Comments by James Adcock on Docket UE-210795
Docket number of this proceeding: UE-210795
Commenting party's name: James L Adcock, Electrical Engineer
The title and date of the comment or comments:
Comments on PSE 2023 Biennial CEIP Update, Docket UE-210795
1/8/2024

In this review of PSE's 2023 Biennial CEIP Update, I express concerns about whether PSE is actually being serious about reaching the CETA requirement to be actually "80% Clean" by 2030. IE 80% non-emitting or Renewables "Primary Compliance."

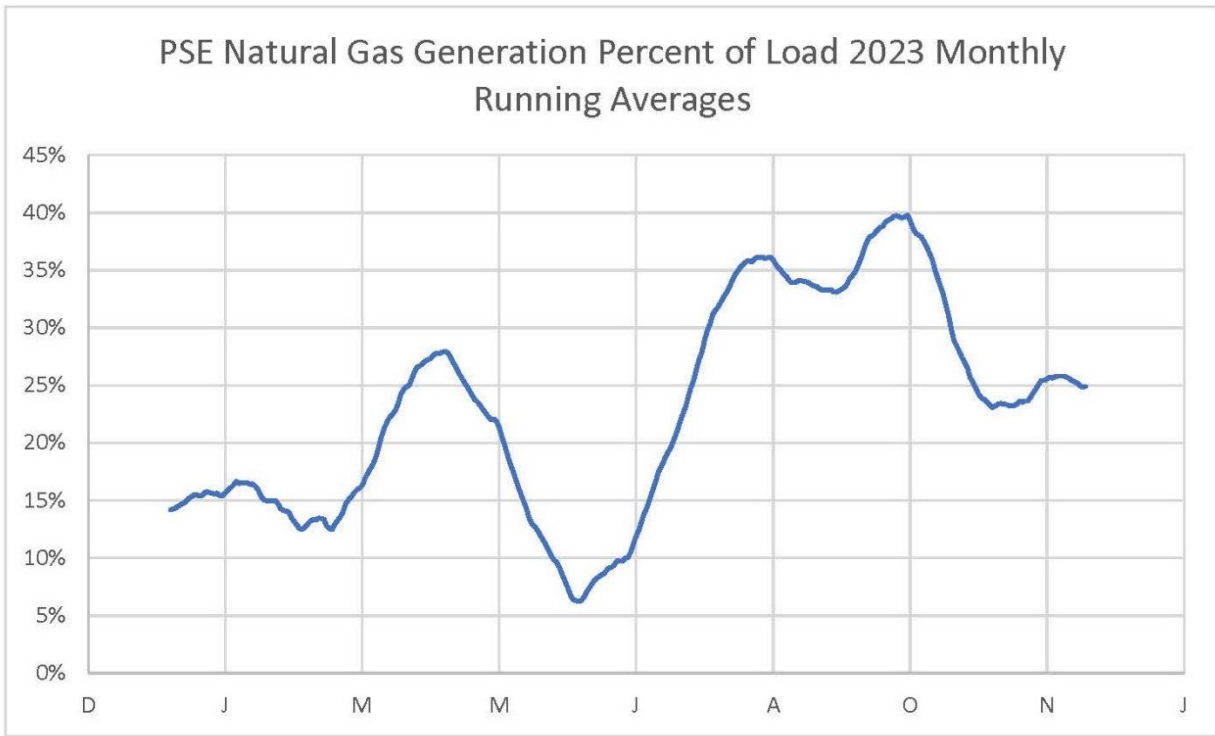
Rather than declining amounts of not-clean generation, PSE has actually greatly increased the amount of Natural Gas Generation used over the last year – the first plot showing the running monthly average percent of load being served by Natural Gas Generation – currently up to 40% -- not the 20% average required by CETA law in 2030.

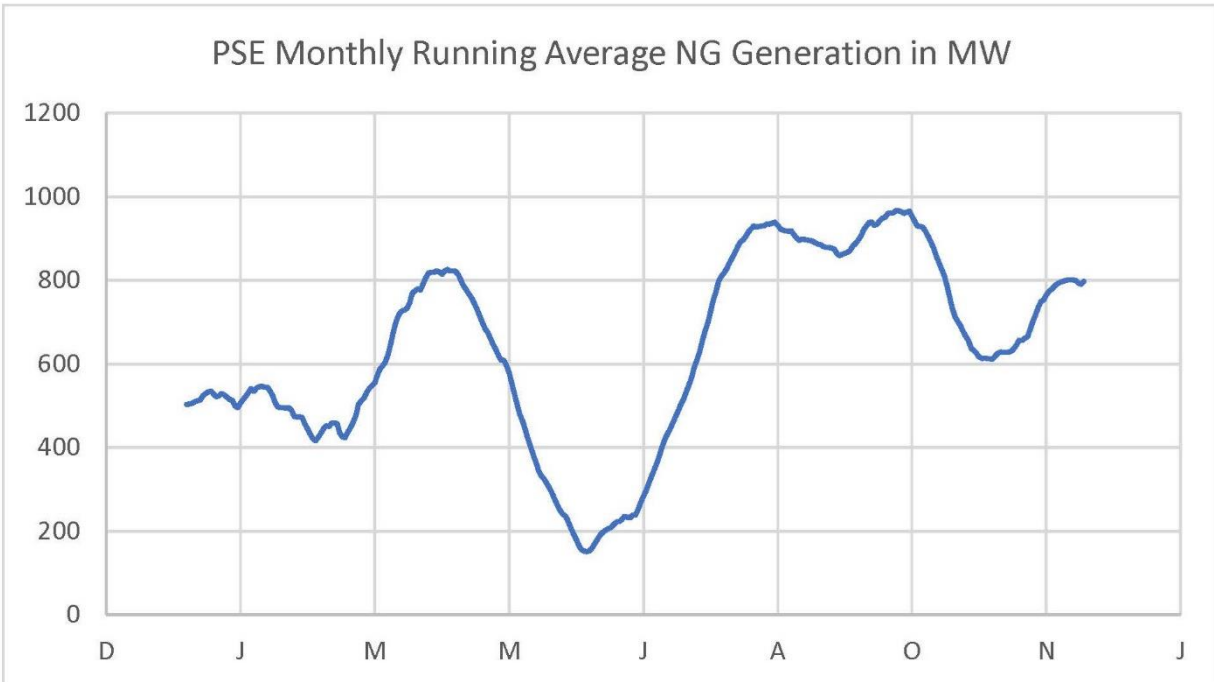
The second, similar looking plot, shows Natural Gas Generation in Average Megawatts [not Peak, but Average – 24/7] – shows PSE Natural Gas Generation serving PSE load in recent months has approached 1,000 Megawatts – 1 Gigawatt – average monthly generation, not peak, Natural Gas Generation:

It is important to note that there is never a time when PSE Natural Gas Generation “goes to zero” – that there is so much Renewable Generation that it cannot simply be used to displace some portion of the then concurrent PSE Natural Gas Generation. PSE would need to roughly triple its current amount of Renewables Generation in order to have so much Renewables that PSE couldn’t simply accommodate those additional Renewables by reducing the concurrent amount of PSE Natural Gas Generation. And this isn’t even counting “Wind Integration” [or “Solar Integration”] -- where PSE swaps Renewable Energy with a Hydro supplier, such as BPA [aka “Storage Contract”] in order to achieve effectively, a flatter, more even source of non-emitting power.

RFP Discussion Page 2.24

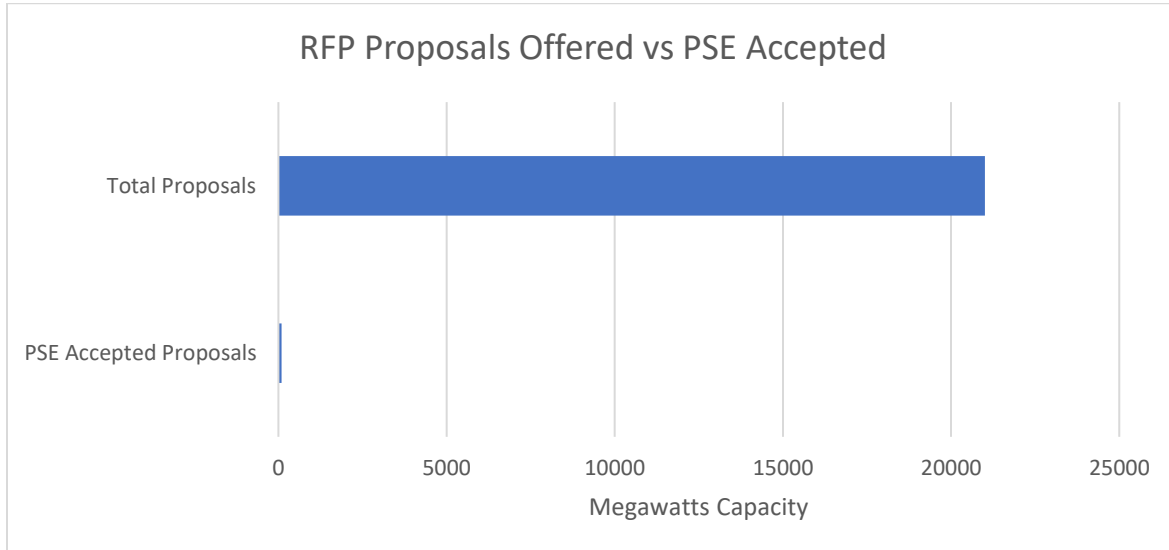
PSE RFP Proposals: 21,006 MW

PSE Accepted Proposals: 90 MW [nameplate] – which is really only about 35 Average MW

IE, PSE accepted less than one half of one percent of the total bids!

I do not believe this PSE choice of actions – or rather inaction -- represents a real commitment to meeting the CETA 2030 “80% Clean” requirements. I would be concerned that future potential bidders will feel highly insulted by PSE's tiny acceptance rate of these bids and will simply not bother to bid in

I ask that Commission review through independent auditor whether or not this extraordinarily low acceptance rate – in the face of PSE’s huge Renewables needs – whether the enormity with which PSE is rejecting offers represents prudent utility behavior given the need to meet CETA 2030 requirements: 80% actually clean by 2030
